### **Addendum 93: Regulation No. 94**

#### **Revision 1 – Amendment 3**

### **Uniform provisions concerning the approval of vehicles with regard to the protection of the occupants in the event of a frontal collision**

Paragraph 6.2.1., amend to read:

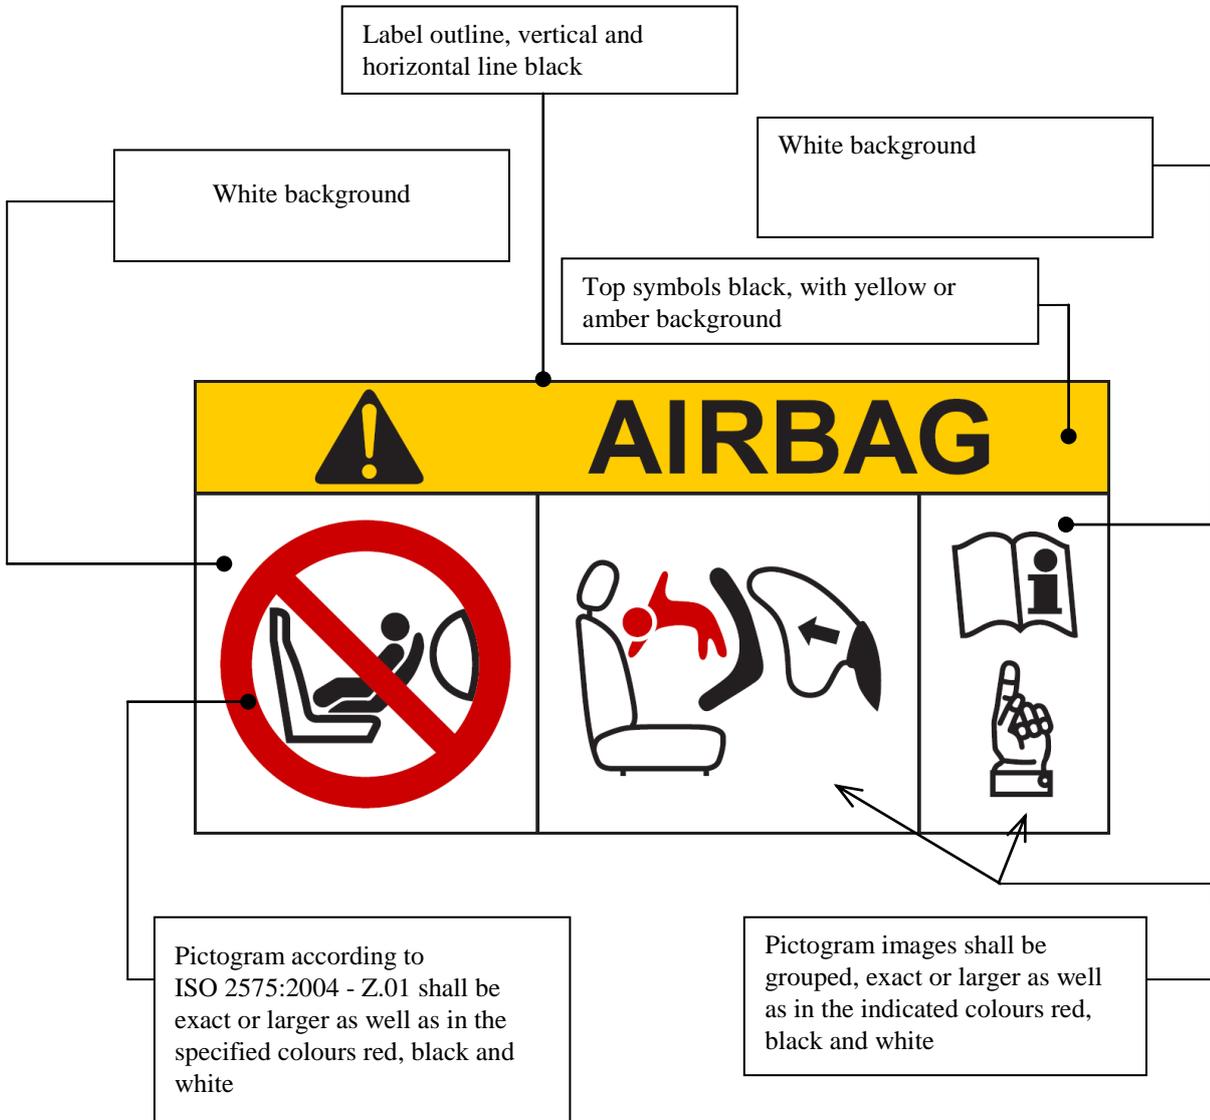
"6.2.1. As a minimum, this information shall consist of a label containing clear warning pictograms as indicated below:

The overall dimensions shall be at least 120 x 60 mm or the equivalent area.

The label shown above may be adapted in such a way that the layout differs from the example above; however, the content shall meet the above prescriptions."
